IN THE MATTER OF Applications CRC192408,
CRC192409, CRC192410,
CRC192411, CRC192412,
CRC192413 and CRC192414 to
the Canterbury Regional
Council, and Application
RC185627 to the Selwyn
District Council, by Fulton
Hogan Limited to establish a
quarry operation at 107
Dawsons Road and 220 Jones
Road.

STATEMENT OF EVIDENCE OF ABIGAIL ALICE SMITH

LANDSCAPE AND VISUAL AMENITY EFFECTS

DATED 14 OF OCTOBER 2019

Figure 1 Proposed Staging of Extraction³

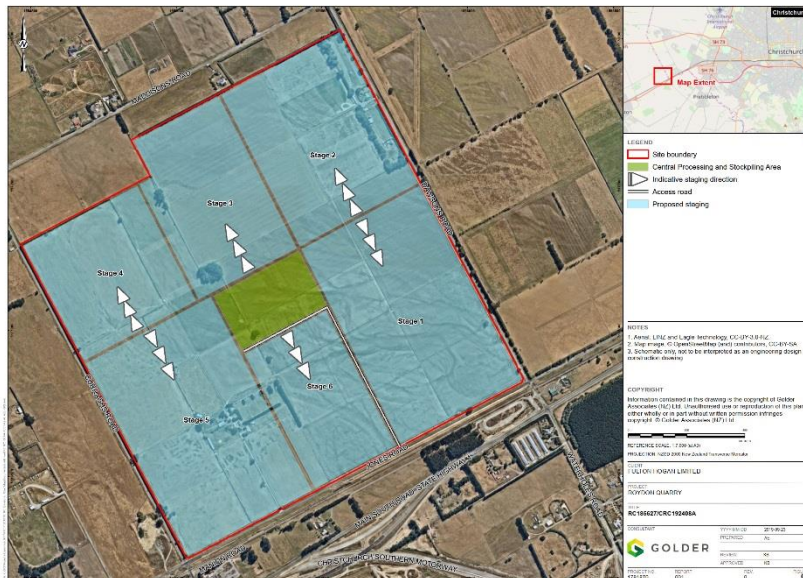
9.1. The s92 response, dated August 2019 included new information regarding the staging of excavation. In Mr Jolly’s Evidence for the Applicant, in paragraph 33 he states “quarrying will be progressive as shown in the staging plan included as figure 1 to Mr Bligh’s evidence”. I have included Figure 1 from Mr Bligh’s Evidence for the Applicant in my evidence below which indicates that quarrying will commence along the Dawson’s Road frontage, of the site. This is the boundary of the proposed quarry in closest proximity to the Templeton Township. Stage one will be followed by Stage two also along Dawson’s Road, potentially exposing Dawson’s Road to quarrying activities for 20 years or more. This is also the timeframe the proposed mitigation planting will be establishing and the period of time that has been identified as having the greatest effect on landscape character and visual amenity.

- 9.2. In order to reduce the adverse effects on landscape character and visual amenity, I recommend that the staging of the proposed extraction is modified to start in a location which is already surrounded by established shelter belts. This would ensure that quarrying activity is not dependent on proposed mitigation planting to reach maturity to provide an appropriate level of mitigation. It would be preferable if excavation could start with Stage 4 or 5 as marked on Figure 1.

- 11.4. In addition I recommend the following;
- a) That the staging of extraction is reconfigured to start at a location within the site already surrounded by established shelter belts; and
